MEMORANDUM

STABILITY OF CUT SECTIONS
From Station 187⁺ to Station 197⁺
Proposed Q.E.W. South Service Road
Twp. of Louth, Lot 1, Con. IX
District No. 4 (Hamilton)
W.J. 67-P-105 -- W.P. 211-63

STABILITY OF CUT SECTIONS
From Station 187⁺ to Station 197⁺
Proposed Q.E.W. South Service Road
Twp. of Louth, Lot 1, Con. IX
District No. 4 (Hamilton)
W.J. 67-F-105 -- W.P. 211-63

DRAWING NO. 67-F-105 A

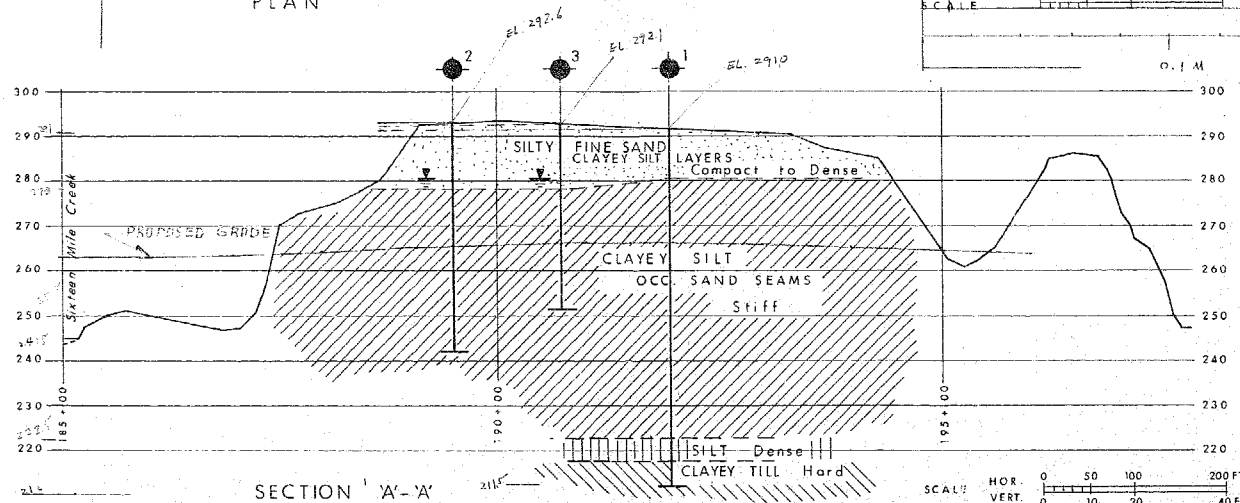
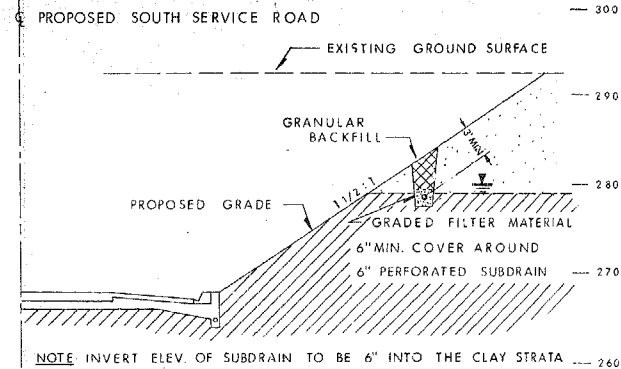
The investigation reveals that the subsoil conditions are favourable for the construction of $1\frac{1}{2}:1$ side slopes for the proposed cuts. The presence of a perched water level in the upper silty sand stratum, however, requires special measures to prevent "loss of ground" conditions resulting from seepage. The most positive solution would be to provide an interceptor drain, surrounded by selected granular graded filter material, and located at the base of the silty sand stratum.

It is suggested that the interceptor drain consist of a standard 6-inch diameter perforated subdrain pipe installed on a 6-inch thick granular pad between Stations 189⁺ and 194⁺. The perforations of the subdrain pipe should be oriented downwards and the pipe should be provided with a granular cover of at least 3 feet thickness for frost protection. A schematic presentation of the suggested installation is shown on the enclosed Drawing 67-F-105A.
